**Environmental
Protection Agency**

RE: HARBISON-WALKER REFRACTORIES
PERMIT NO. 3IE00043
PORTAGE COUNTY
WINDHAM

On July 20, 2011, an inspection of the above referenced facility was conducted. The facility was represented by Mr. Joseph E. Berger, Facility Engineer and Mr. Brett Bunker, Safety Coordinator. The purpose of the inspection was to: (1) examine the facility's outfalls and receiving stream along with the facility's compliance status with respect to the terms and conditions of the above-referenced National Pollutant Discharge Elimination System (NPDES) permit and (2) determine required additional actions to be undertaken as part of the permit renewal process.

Figure 1

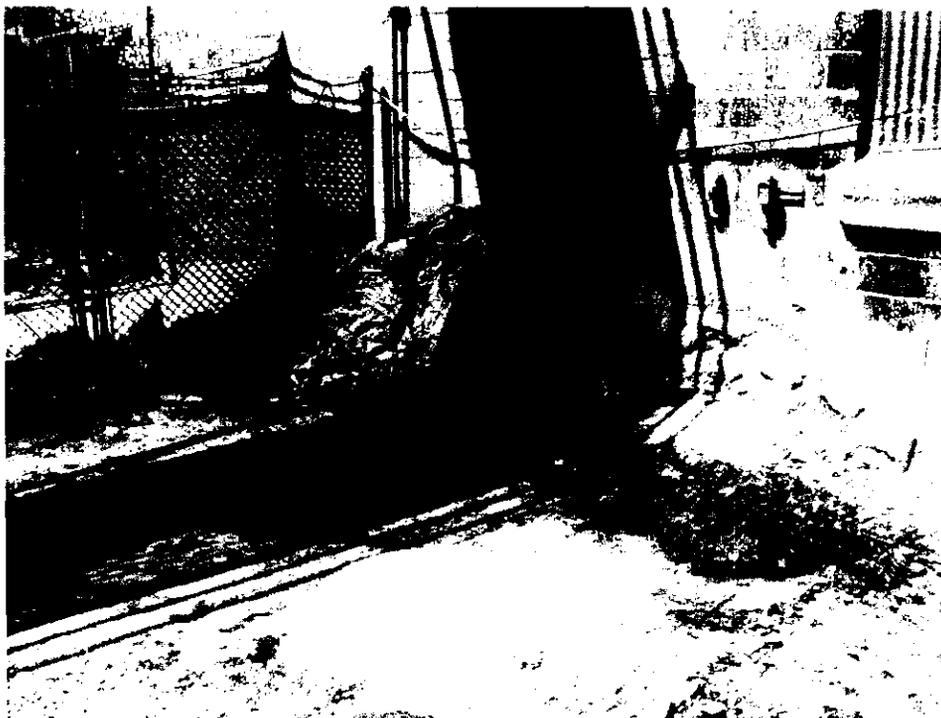
15. It was observed that better housekeeping operations are required in the following areas due to the excessive solids build up from entering waters of the state via the storm sewers:

- a. Area by dumpster, See Figure 1
 - b. Emag conveyer belt area , See Figure 2
 - c. Storm manhole by the Praxair system, See Figure 3
 16. Mr. Bunker performs monthly stormwater inspections at the facility. The above areas may need to be monitored more frequently.

17. You indicated that the yard area is swept once a month by Everbrite. More frequent sweeping may be required.
 18. The facility's Stormwater Pollution Prevention Plan, SWPPP, was last updated in April 2011. The facility's SWPPP should directly address the areas listed in item 15 above.

Please notify this office in writing, within 14 days receipt of this letter, of your intentions to resolve items 12, 15, 16, 17, and 18. A follow-up inspection will be conducted subsequent to the completion date.
